PRELIMINARY DRAINAGE PLAN

CREEKSIDE SOUTH AT LORSON RANCH

Engineering Review

PUD SP-20-1001

FIGURE NO.
1

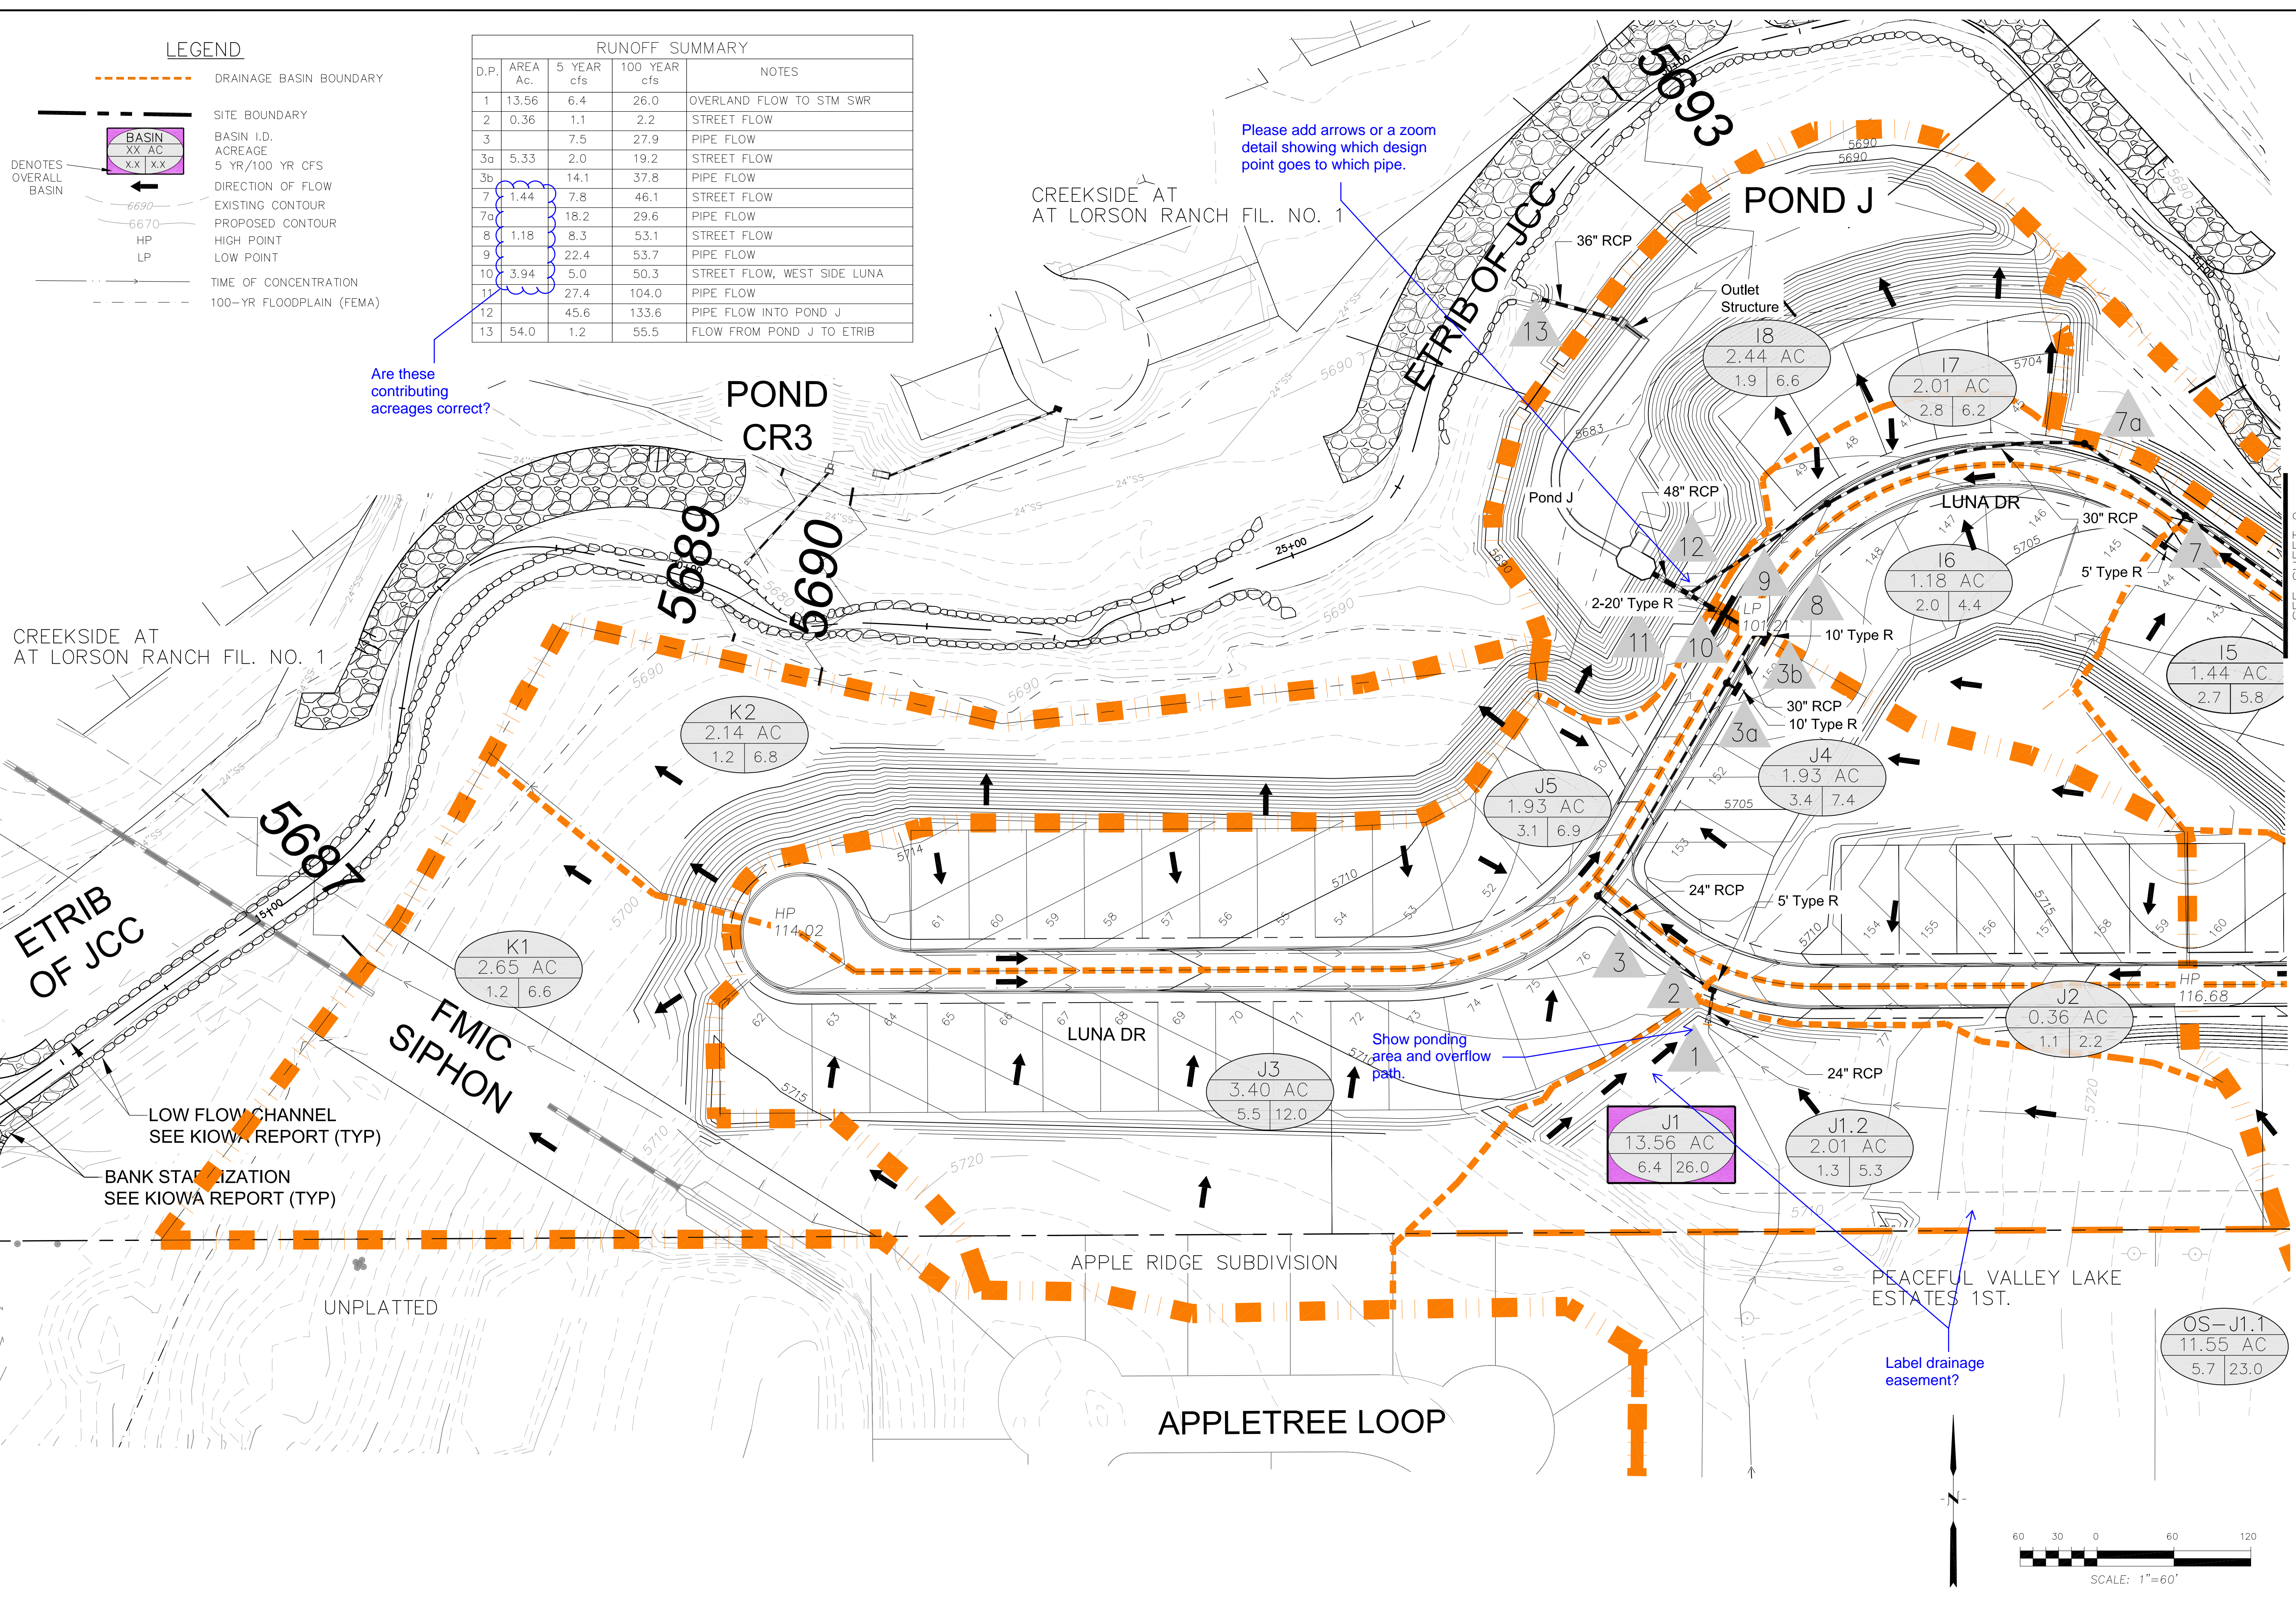
Are these contributing acreages correct?

Please add arrows or a zoom detail showing which design point goes to which pipe.

Show ponding area and overflow path.
